10 August 2021

This memorandum provides final responses to the Request For Information (RFI) aspects raised by Department Planning Industry and Environment (DPIE) on 7 May 2021 (Sections 1 - 8) and additionally on 21 May 2021 and 30 June 2021 (Section 9). Submission comments received from the Department's Biodiversity and Conservation Division (BCD) in May, June 2021 and subsequently are also addressed in Section 1.

Figure 1-2

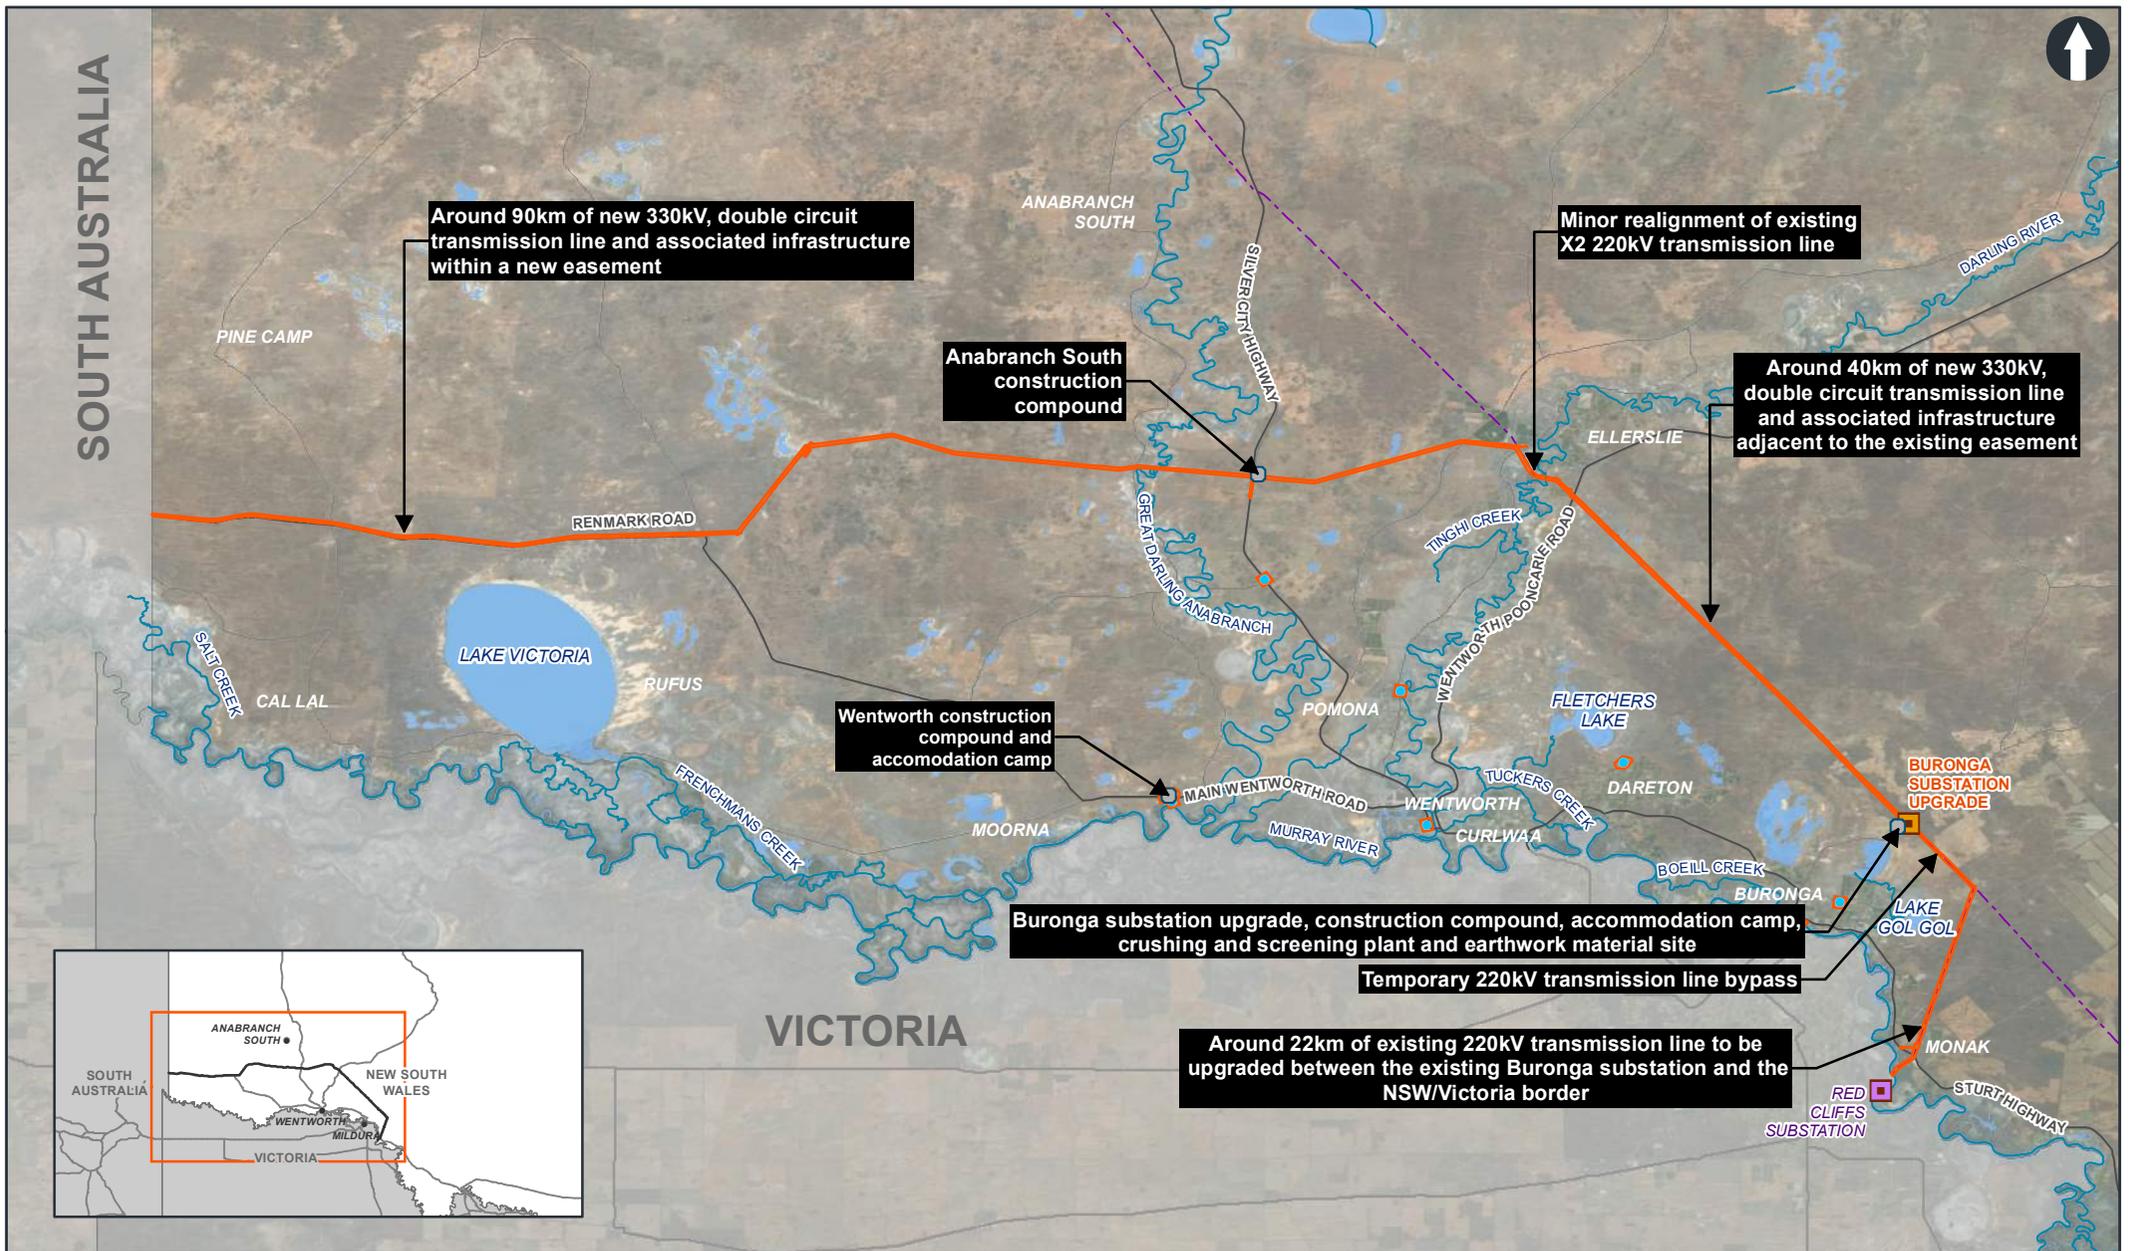
- > Figure 1-2: Ensure arrows align with project infrastructure location

Figure 1-2 has been updated to ensure arrows align with the location of each element of proposed project infrastructure (refer to Appendix C).

**Figure 6-3c**  
**Construction overview**

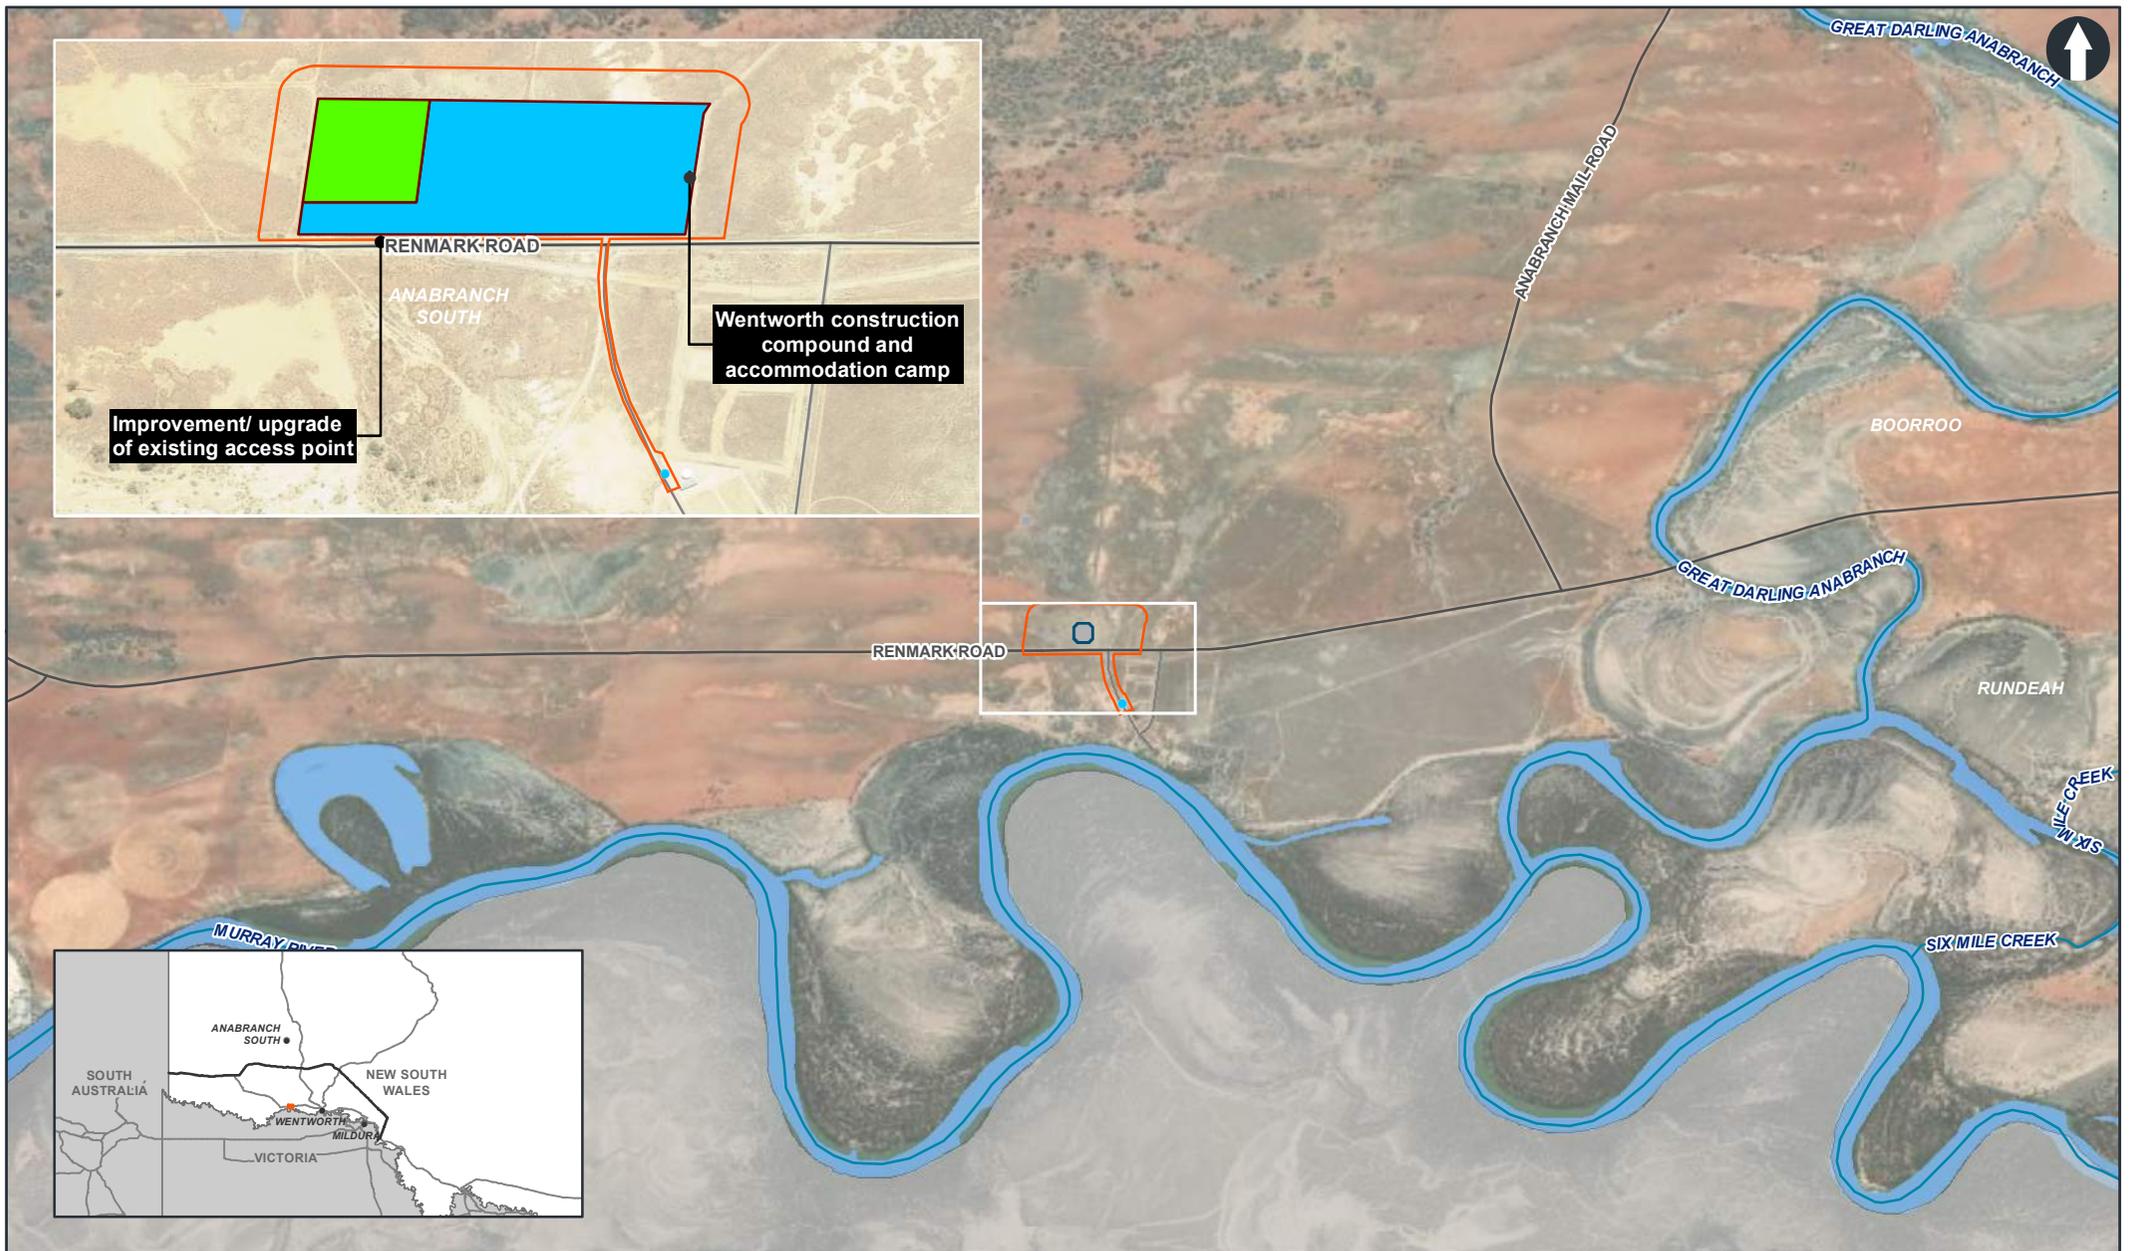
- > Figure 6-3c: Hendy Road label is covering WSP location

Figure 6-3c has been updated to ensure that the label representing Hendy Road has been moved to avoid overlapping the proposed location of the water supply point at Buronga (refer to Appendix C to this memorandum).

Figure 6.8

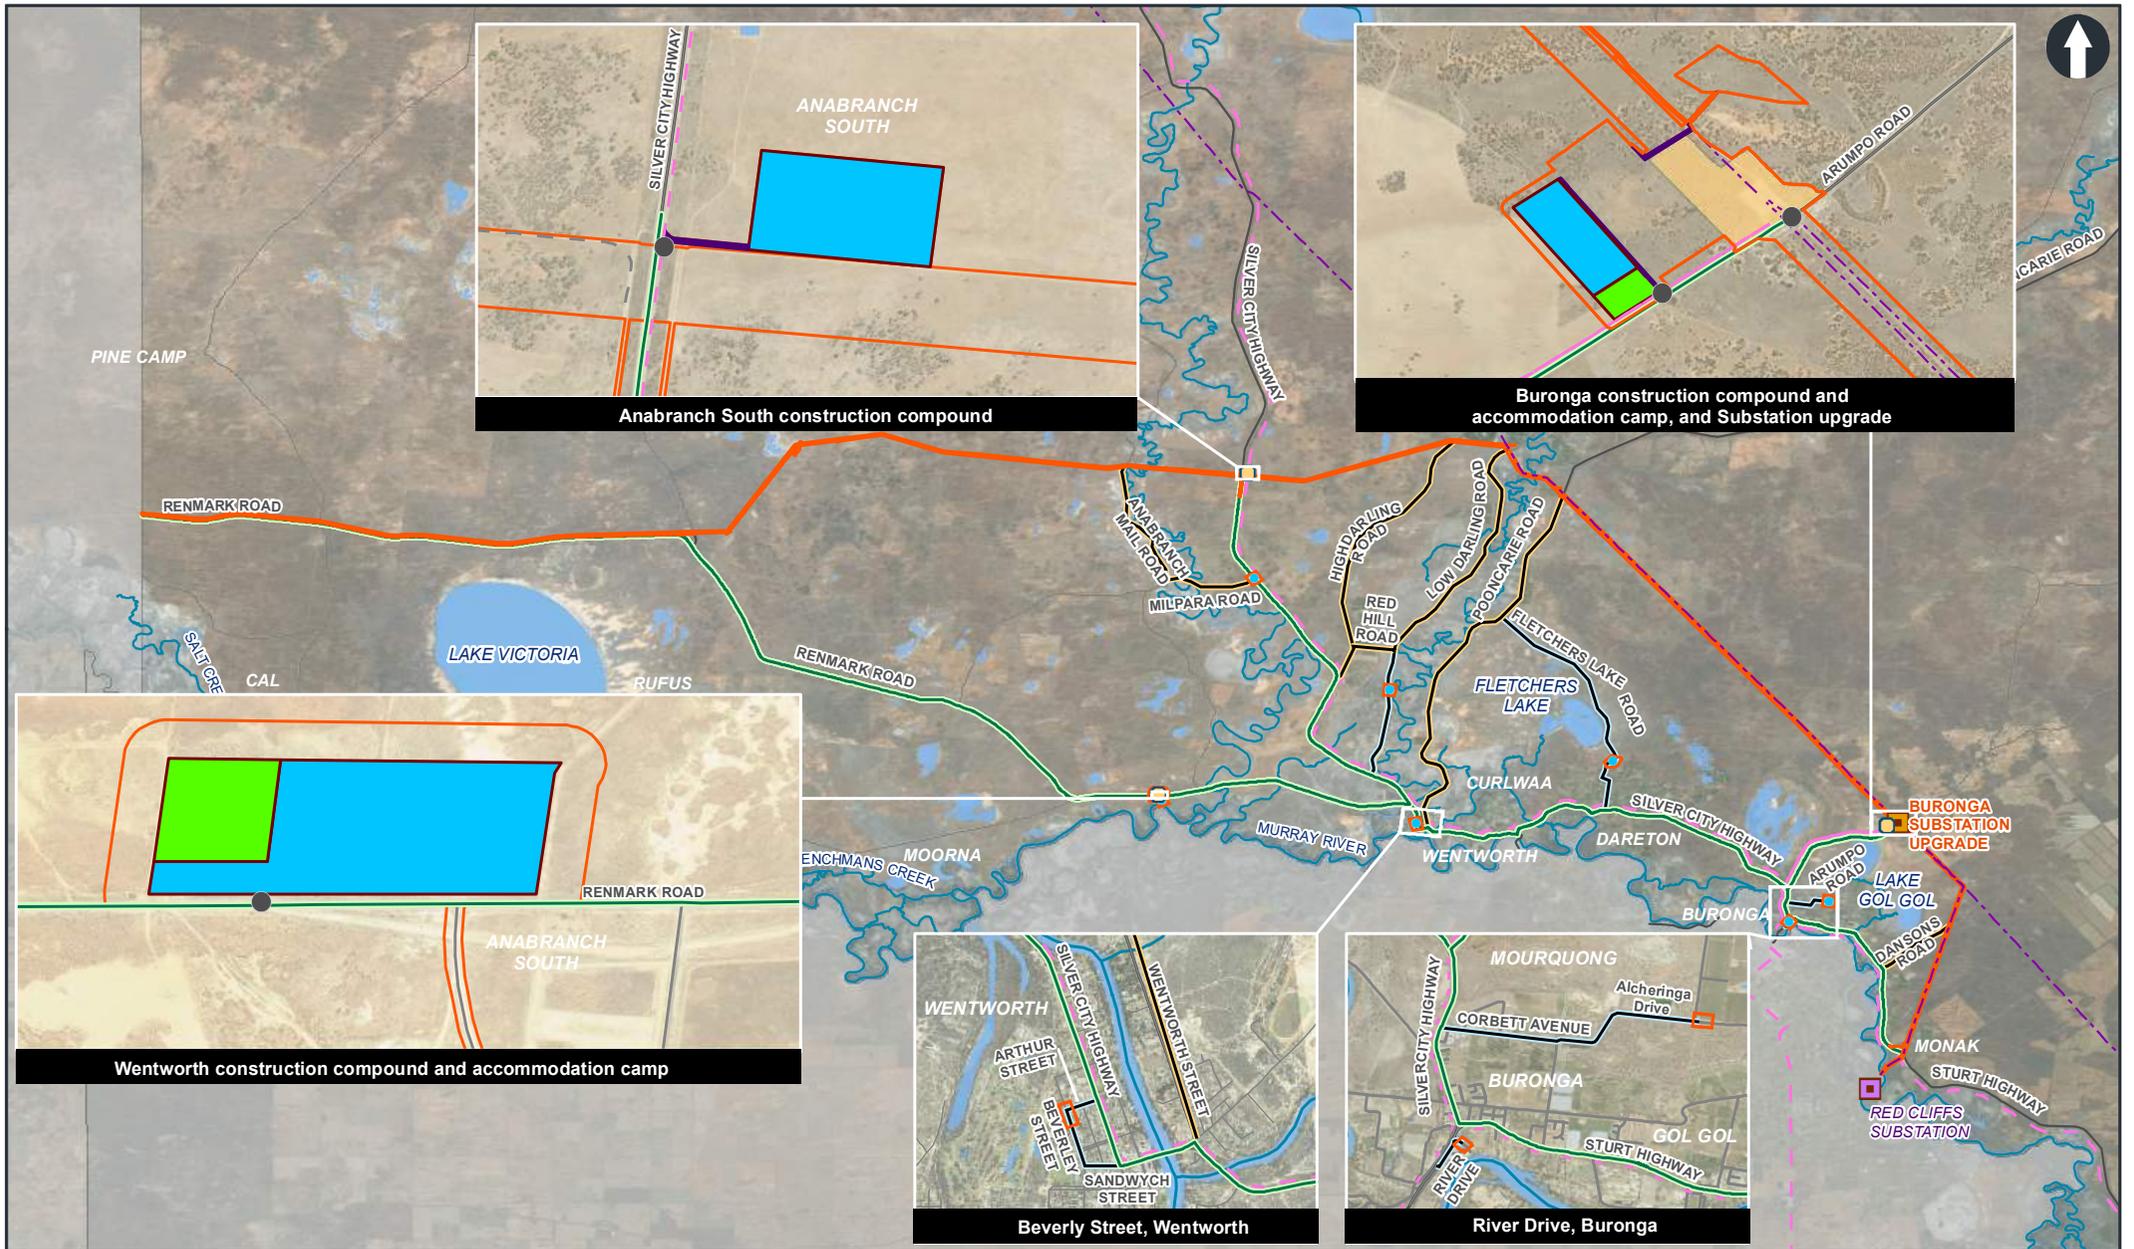
- > **Revise maps and figures to include a defined ‘project site’ that encompasses all works associated with construction and operation of the project,**
- > **Provide updated Figures 1.2, 17.1 from the EIS and Figure 6.3 series and Figure 6.8 from Appendix B - Revised Proposal Description – construction of the Amendment Report.**

Figure 6.8 has been revised to identify the primary, secondary and water access supply routes that would be used by construction vehicles between work areas and the main construction compounds and accommodation camps. The revised figure is provided as part of Appendix C to this memorandum.
